**STAFF REPORT: DECEMBER 10, 2025 MEETING**

**APPLICATION NUMBER: HDC2025-00616**

**ADDRESS: 4325 LESLIE**

**SCOPE: REPLACE HISTORIC WINDOWS, ALTER DWELLING**

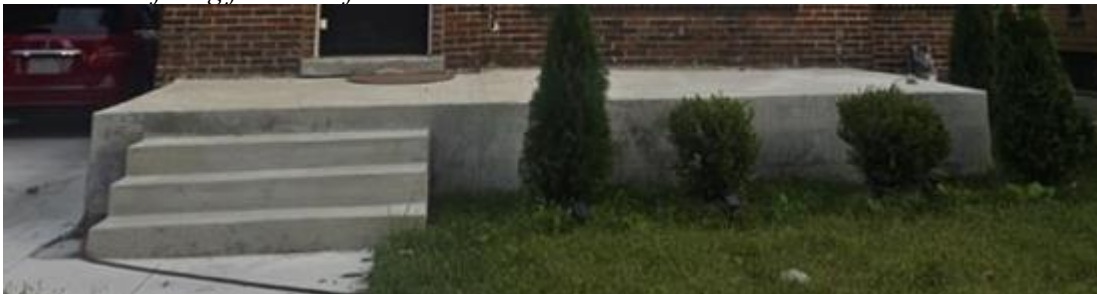
- The **historic, character-defining bowed bay window** with lattice-patterned leaded glass should have been preserved and repaired. If repair was not possible, Standard 6 requires that the new window should have matched the historic in design, color, texture, other visual qualities, and, where possible, materials. The bay window’s replacement does not replicate the historic window in any way—it lacks the dimensionality of the bay window, leaded glass, tall, narrow proportions, and the complementary color for the architectural details, and the vinyl introduced a plastic texture, detracting sheen, and blocky proportions. Where a projecting, detailed bay window with three tall, narrow, leaded sashes was, now is a flat window with two horizontal sliding sashes and wide rails and stiles in bright white vinyl.

*Google Street View August 2018. Here, the narrow arched gable window remains, the bay window on the house's upper right has the lattice-patterned leaded glass, the window on the furthest right of the triple windows at the second floor has its leaded glass, the two windows to the left of the group of four on the first floor have their leaded glass, the left window of the first-floor pair to the house's right retains its leaded glass, the arched window next to the front door remains in place with its leaded glass, the pointed-arch doorway and original door are still in place, and the three brick piers, low guardrail, and the capped wing walls are still in place at the front porch. (The side rail on the front porch is still in place as well.)*

*Current. Between 2022 and 2024, the bay window and its leaded glass on the house's upper right was removed, all of the rectangular leaded-glass windows on the front of the house were removed, the arched window next to the front door and its leaded glass were removed, the pointed-arch doorway and original door were removed, and the three brick piers, low guardrail, and the capped wing walls at the front porch were all removed. The narrow, arched window in the gable remains and retains its leaded glass. Painting the half-timbers white (like the stucco) neutralized this character-defining architectural feature. (Staff photo, November 2025)*

- The number of windows at one second-story, centered opening at the front façade was reduced from three to two as the new units do not match the original in dimension.

- The number of windows at one first-story, centered opening at the front façade was reduced from four to three as the new units do not match the original in dimension.

- The number of windows at one second-story opening at the front façade in the half-timbered projecting bay (at former second-story bowed bay) has been reduced from three to two units as the new units do not match the original in dimension. Also, as the new units are horizontal sliding units, they do not match the original in operation.

- The historic, character-defining features that were removed on the house's front façade (including the windows, front door, and front porch) were removed in conflict with Standard 2, which states that the removal of historic materials shall be avoided. If the features were deteriorated beyond repair, the features should have been replicated in kind as per Standard 6 but were not.

*Sanborn Fire insurance map, August 2002. 4325 Leslie is outlined in red. Note that the current rear sunroom addition is not present at this time.*

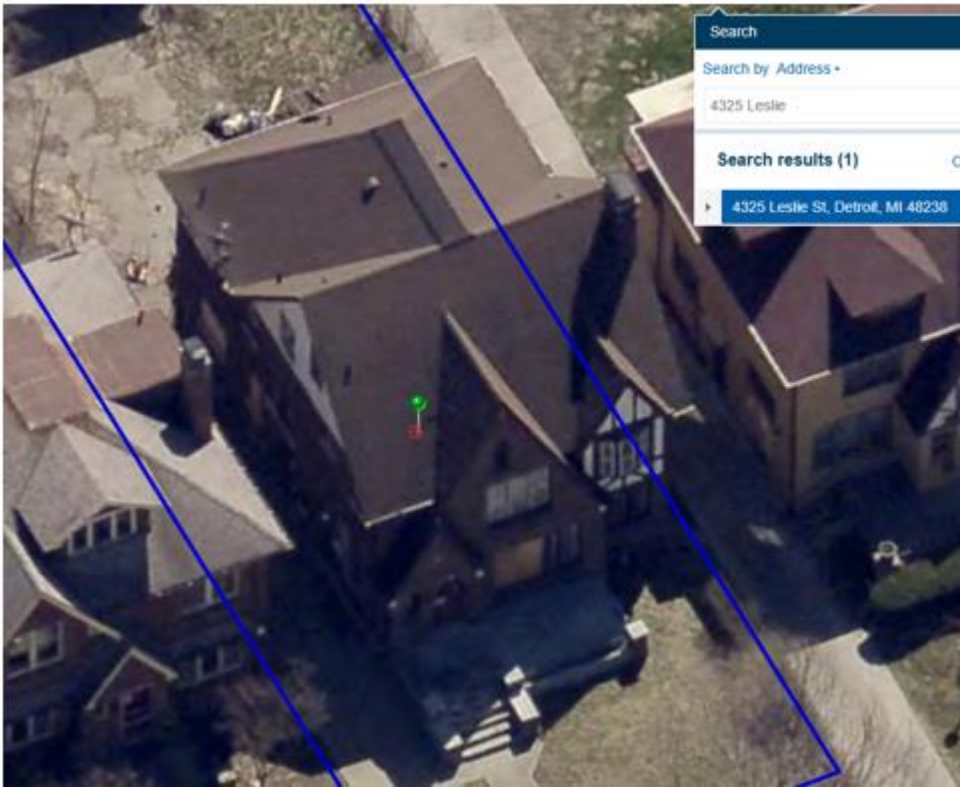
- The house also had (and retains) **a rear sunroom**. The sunroom was not present as of 2002, per the 2002 Sanborn map, below. However, it has been present at the rear wall since at least 2005. The exterior cladding materials and windows remained consistent through April 2022. It likely had aluminum storm windows and aluminum siding. Its windows and siding were both replaced with vinyl by March/April 2024 without Commission approval.

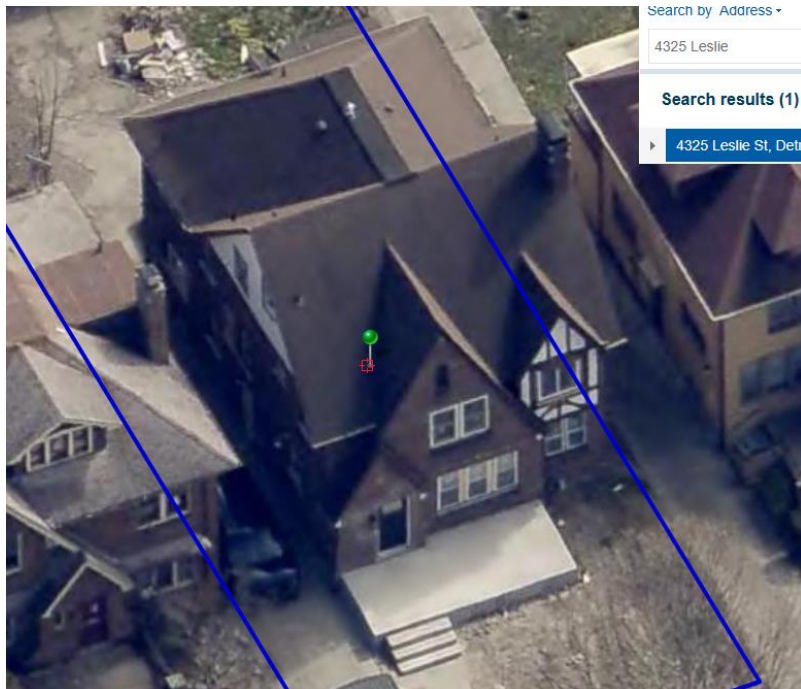
*Eagleview/ConnectExplorer, March-April 2024, house's west side showing white windows after having been boarded, and rear sunroom at the house's southwest corner showing that windows and siding have changed since 2022. The door leading onto the open porch near the house's southeast corner is new, as is the brick infill of the second-story window near the house's southeast corner.*

- Although the non-historic rear sunroom is not of historic age and is not a distinctive, character-defining feature of the house, staff finds that the recently installed vinyl windows and vinyl siding are not compatible with the Tudor-style house. Replacement material in the historic district, even for non-historic materials like aluminum siding and aluminum storm windows, must be compatible with the historic house. The proportions, texture, sheen, and color of the vinyl siding are not compatible with this Tudor-style house.

- Also proposed with this application is the **brick infill of two window openings**—one on the east side of the house and one at the second story on the rear. The window opening on the rear of the house has been shown boarded and painted dark brown on Eagleview/ConnectExplorer images since at least 2014. (In 2005/2006 and 2011, it is hard to see that window clearly.) The infilled window on the east side is never shown in Eagleview or Google imagery. The *Guidelines for Rehabilitating Historic Buildings* recommend against blocking in windows. (They state, “*Not Recommended: Changing the number, location, size, or glazing pattern of windows through cutting new openings, blocking-in windows...*”) Staff does not find it appropriate to infill these window openings, especially with bricks that contrast sharply with the reddish-brown bricks of the house, and that are laid in a stacked bond pattern when the rest of the house has running bond bricks. The openings should be restored as windows, and if that isn’t possible, these openings should be infilled with bricks that match as closely as possible to the house’s existing bricks and should be laid in a running bond and slightly inset (from ½” to 1” in depth) to blend in with the existing materials while also indicating an alteration, instead of drawing attention to themselves as they do now.

- The nonhistoric windows and siding on the rear sunroom addition at the house's southwest corner were replaced with white vinyl. Vinyl is not a compatible material for this historic house. Standard 9 states that exterior alterations shall not destroy historic materials that characterize the property and shall be compatible with architectural features. As stated, vinyl's texture, sheen, and, in this case, color, make it an incompatible material with this house's architectural features.
